DESIGN REVIEW BOARD MARCH 20, 2020

ALPHARETTA CITY HALL
COUNCIL CHAMBERS
2 PARK PLAZA
8:30 AM

- VII. PUBLIC HEARING
 1. 09:10 - 09:30 North Point Eco Guidelines
Kathi to discuss North Point Guidelines
 2. 09:30 - 09:40 DRB200011 SP&G Attorneys 284 North Main St
review signage

3. 09:40 - 10:10 DRB190054 The Felix School 500 Arts Summit
review exterior revisions
 4. 10:10 - 11:00 DRB190028 Lazy Dog 10800 Haynes Bridge
review new construction

DD4.0A

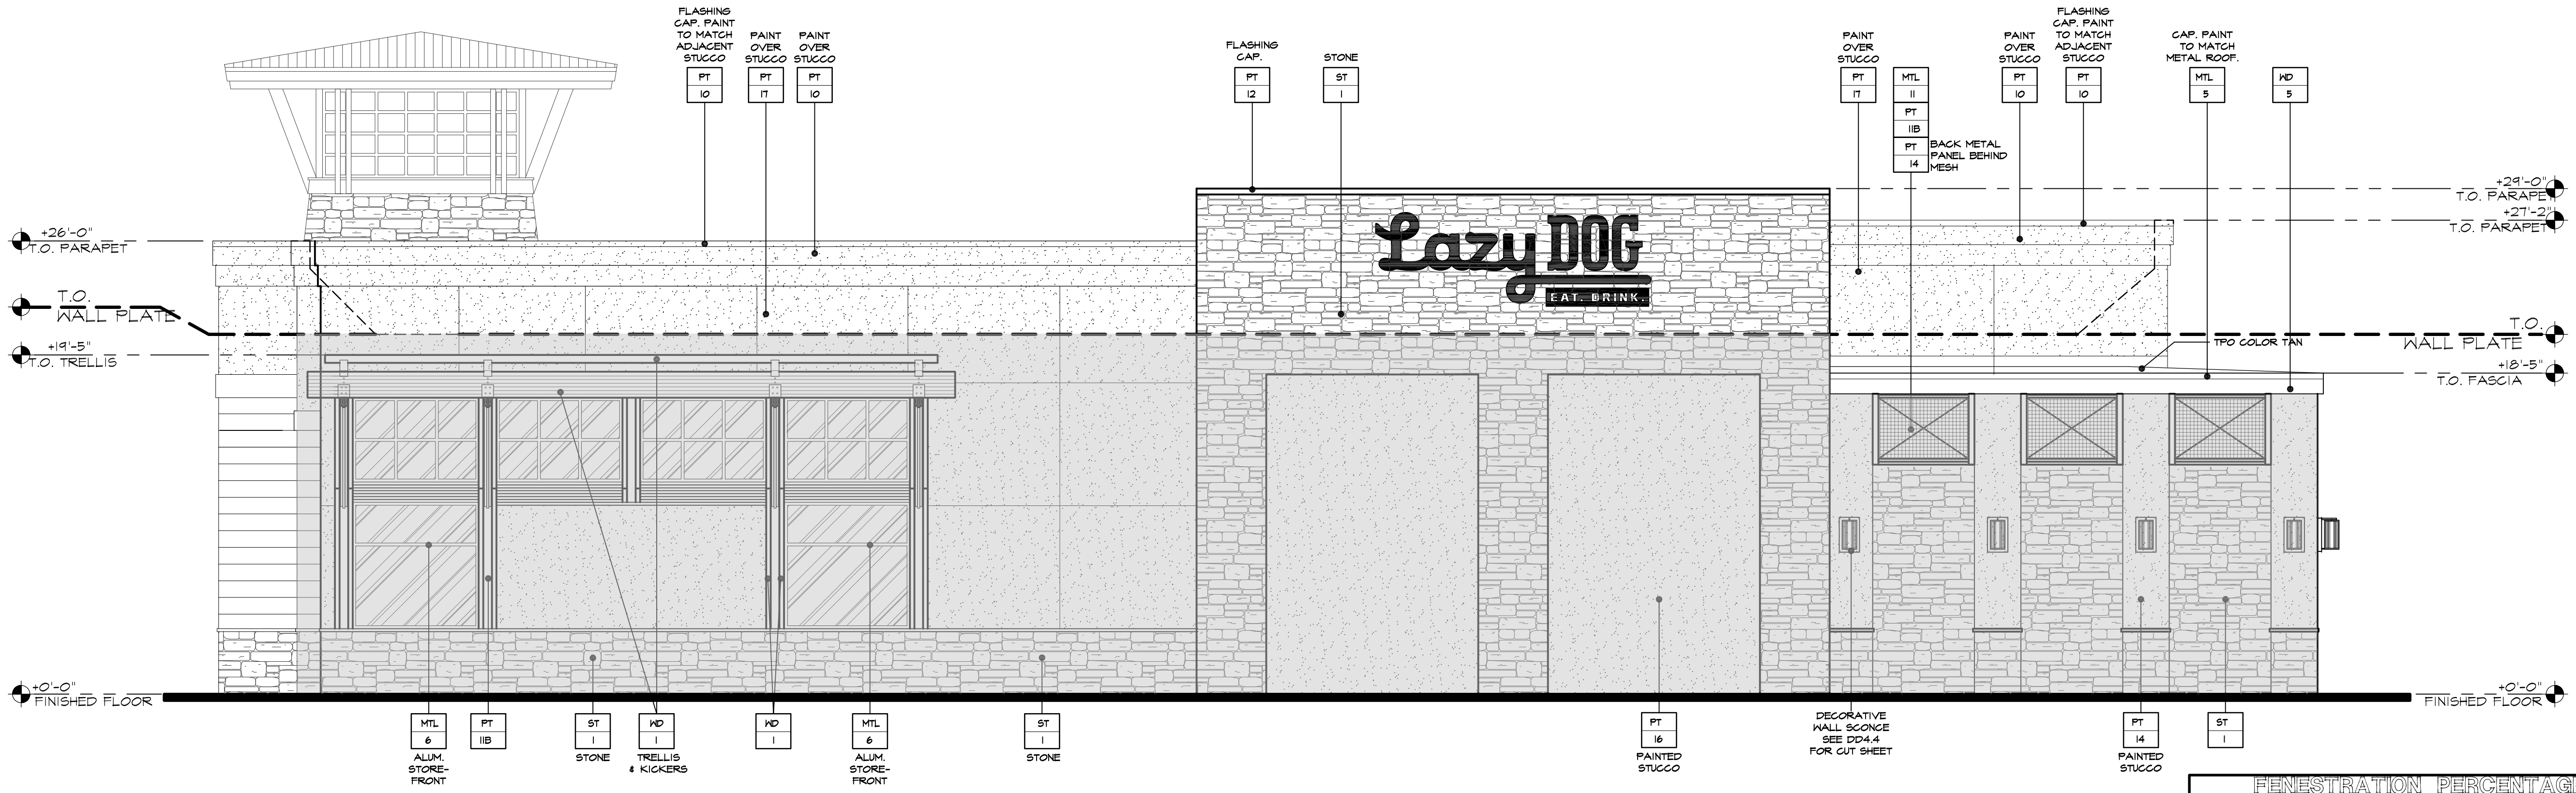
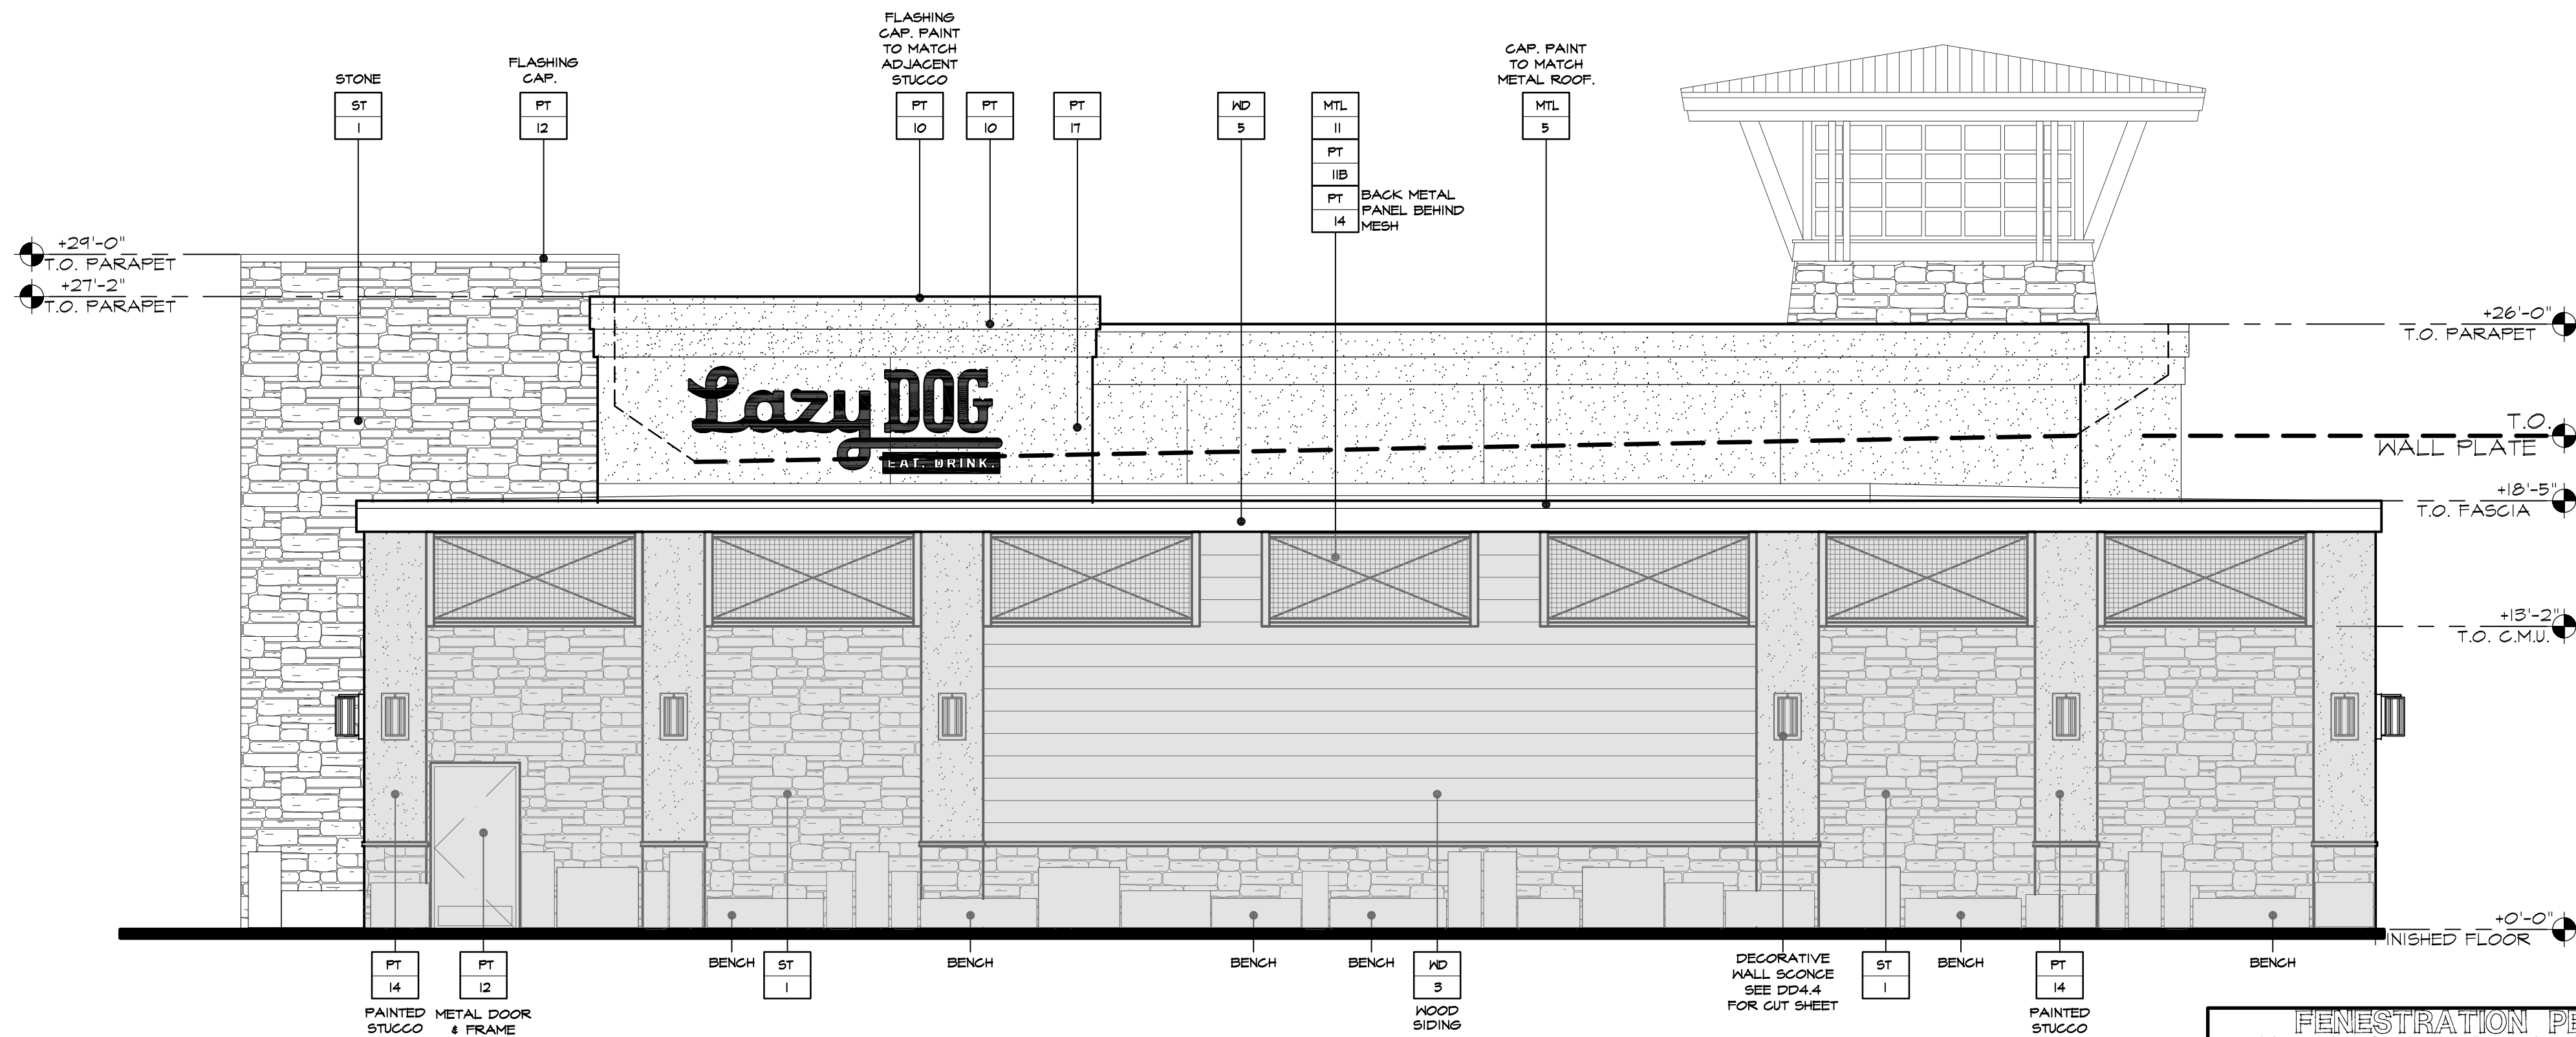
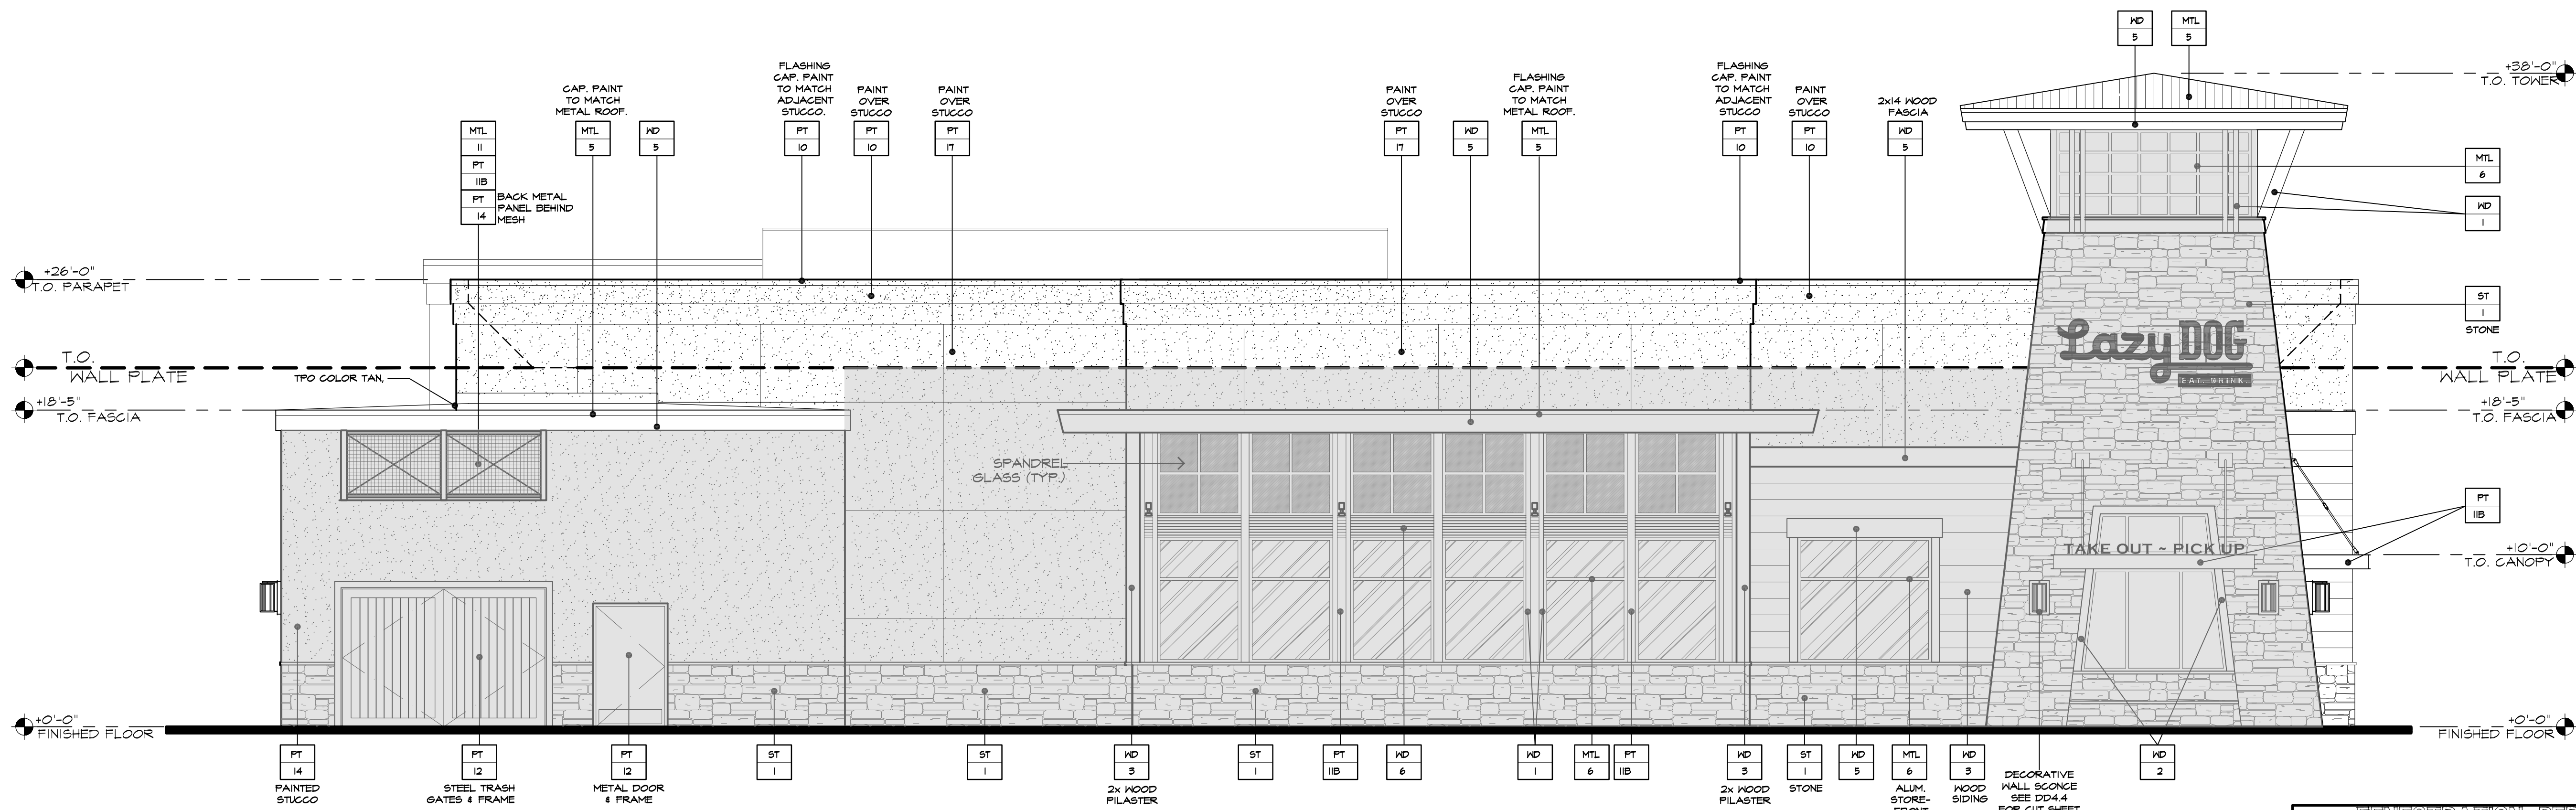
- Revise building floor plan per planning comments to add more glazing on the east elevation

- Added sheet to set to show fenestration calculation

PLANNING FENESTRATION REQUIREMENTS = 25% MIN. PER ELEVATION
4 ELEVATIONS PER BUILDING = 100%+
LAZY DOG FENESTRATION TOTAL FOR ALL 4 ELEVATIONS = 112%

DD4.3A

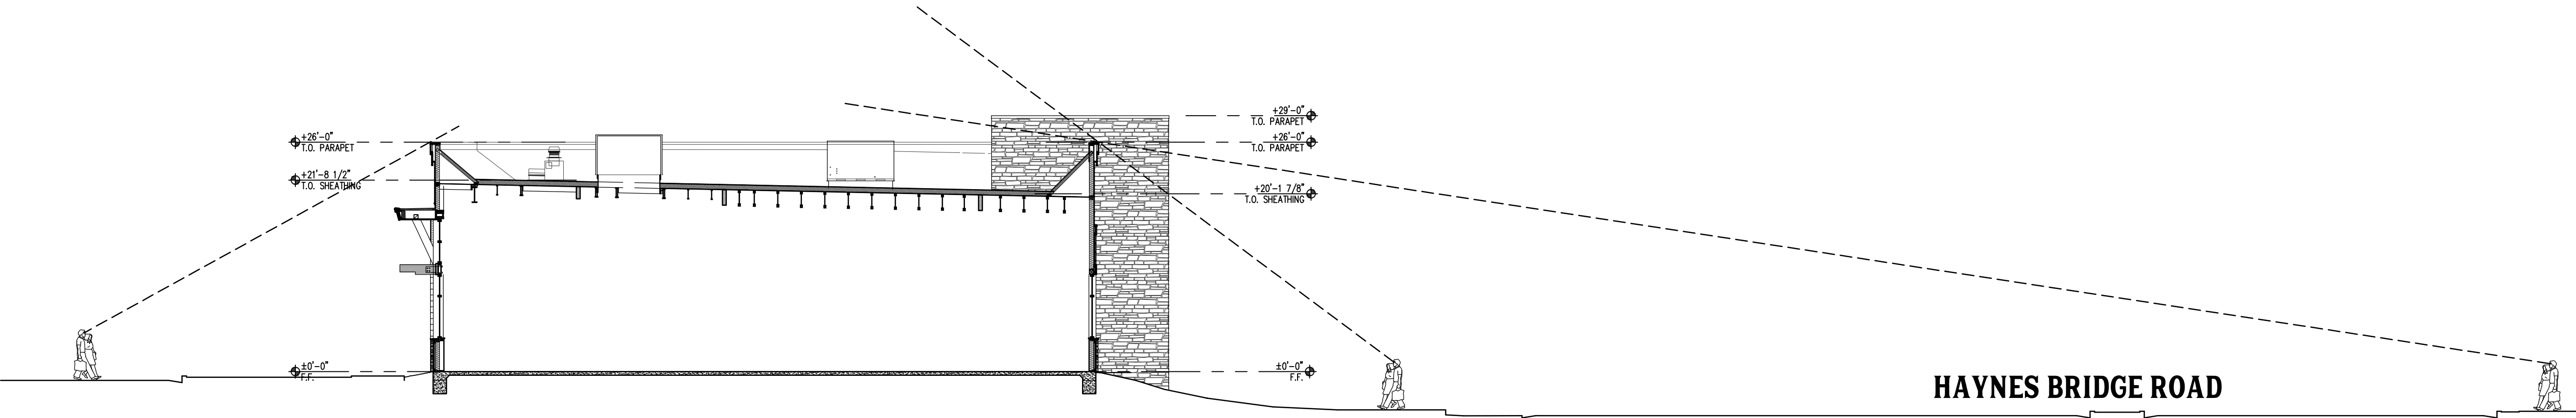
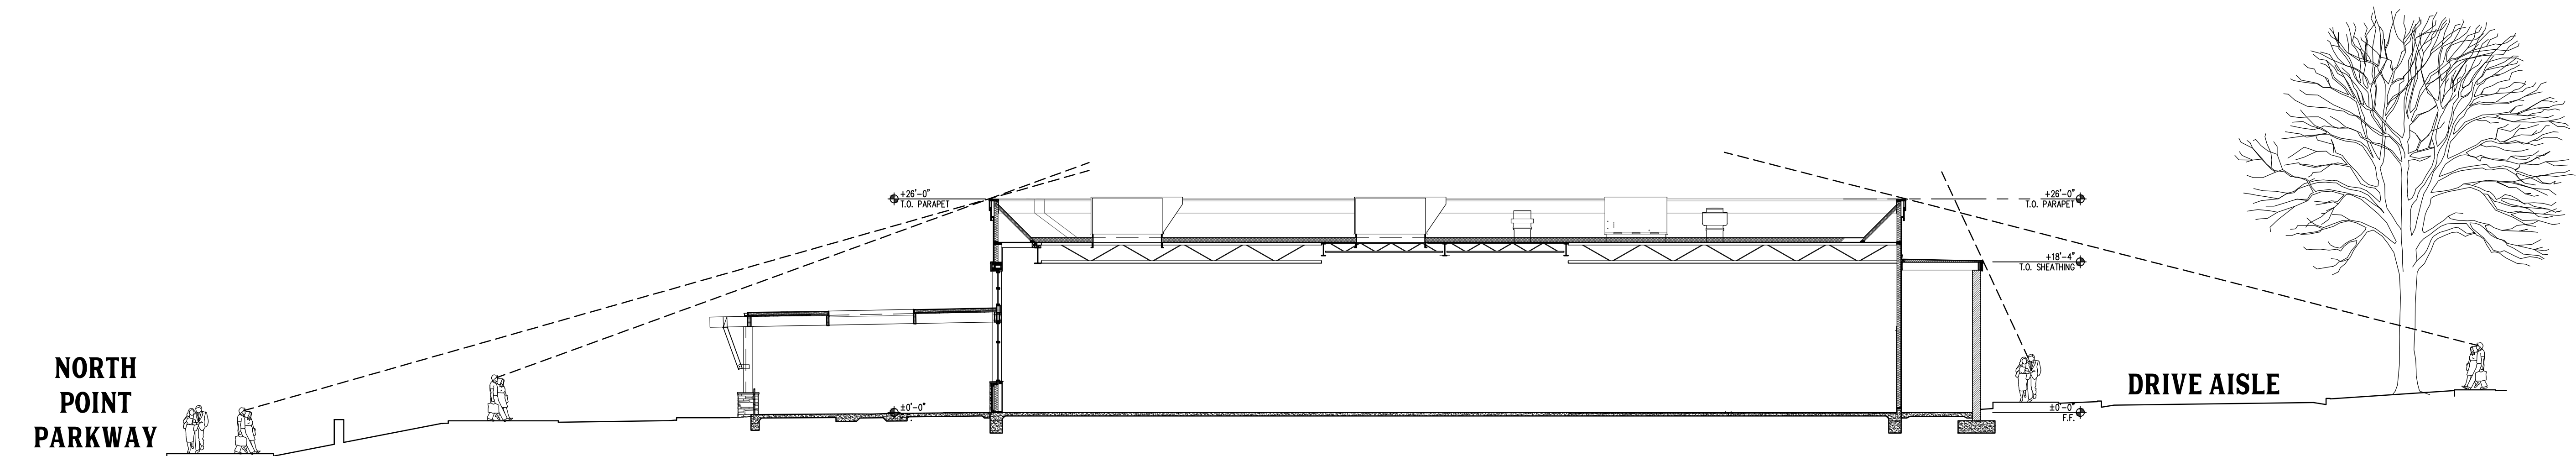
9. Site line study from several areas along the R/W showing RTU's is required – See sheet DD4.3 & DD4.3A
10. maximum 50% stucco on any elevation (not including parapet, maybe) – See sheet DD4.0 & DD4.1 for stucco percentages

SITE LINE STUDY
